RE: Springbank Off-Stream Storage Project (SR1) – Design Review

SRI Springbank Off-Stream Storage Project

Design Review

Figure 3. Diversion Inlet cross section from Final Preliminary Design Report (Ex 159 page 343)

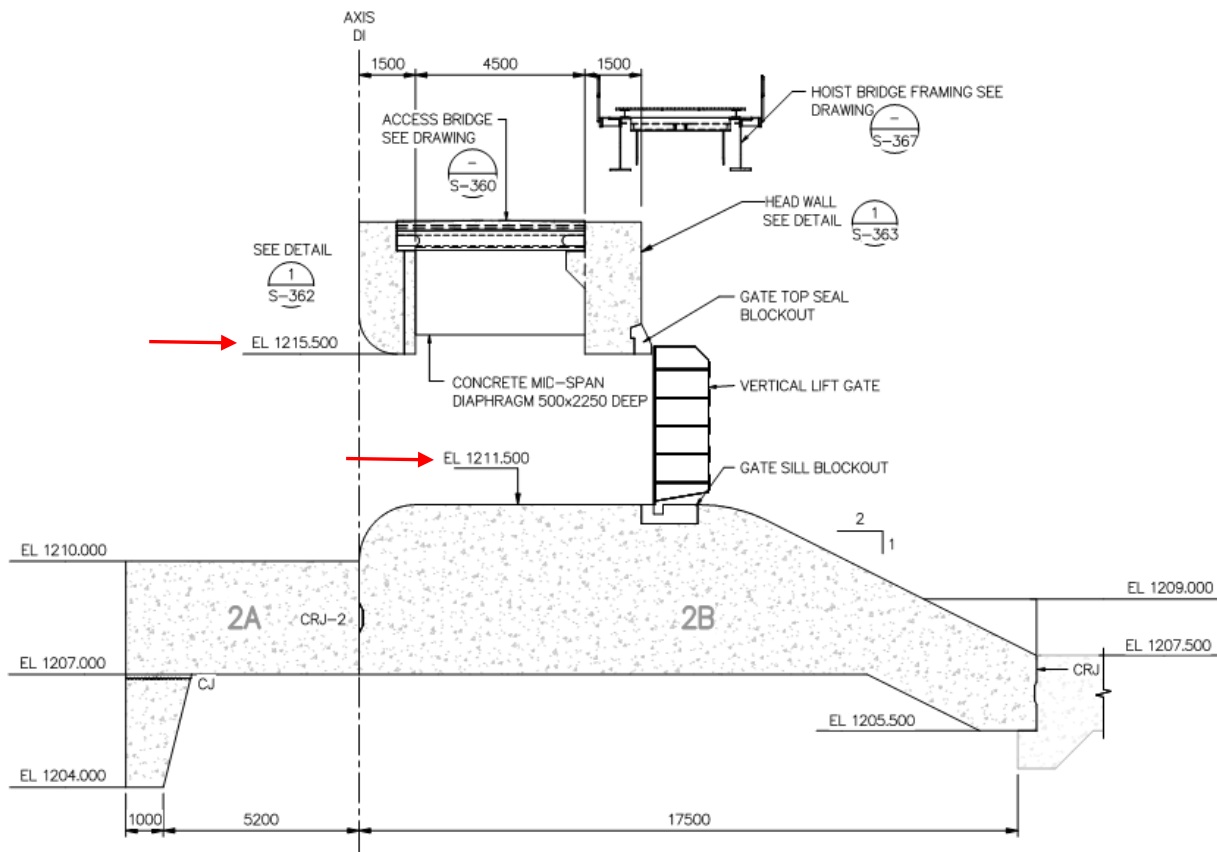
Figure 3 shows Section B taken from Drawing 73396S-331 in the Final Preliminary Design Report (Ex 159 page 343). The bottom elevation of the access bridge across the diversion inlet (to the gate hoists) is shown as 1215.5 m. The inlet invert elevation is 1211.5 m. This gives a maximum flow depth below the access bridge of 4.0 m before the water surface

hits the bottom of the bridge and the curvature on the bottom of the bridge girder indicates water levels higher than this are anticipated.

Utilizing the rectangular broad-crested weir equation, Equation 1 (Smith 1978), with a coefficient of discharge (C) of 1.7, a total width (L) of 40 m, and a flow depth of 4 m gives an approximate weir discharge capacity of 544 m³/s.

The Diversion Inlet rating curve given in Section 8.2.4.2 of the Final Preliminary Design Report (Ex 159 page 100, Figure 19) shows water surface elevations higher than 1215.5 m, up to 1217 m. We recommend that the access bridge design be reviewed to ensure that adequate freeboard (between the bridge and water surface) is achieved during passage of the design flow of 600 m³/s and that the bridge will not suffer damage due to ice, and high water levels during a flood event.

Figure 4. Diversion Channel cross section at station 13+400 looking downstream towards the Storage Dam (not drawn to scale)

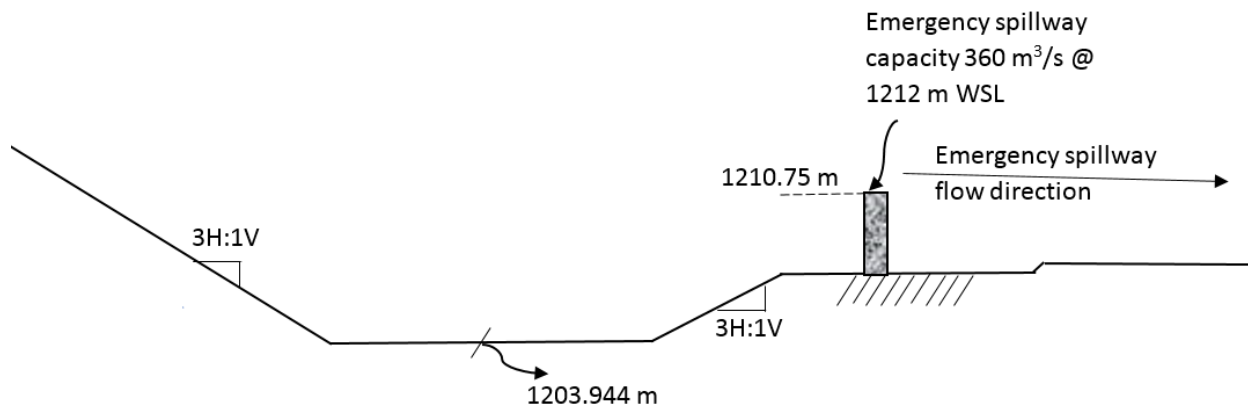
Additionally, the Emergency Spillway is positioned at such a high elevation within the Diversion Channel that it cannot prevent the Storage Dam from overtopping if the Diversion Inlet gates are left open during a large flood event. Refer to Figure 4 below for the Diversion Channel cross section at the Emergency Spillway location (station 13+400).

Based on the CDA Dam Safety Guidelines (CDA, 2013), the spillway of a dam must be able to discharge the IDF while maintaining the minimum required freeboard.
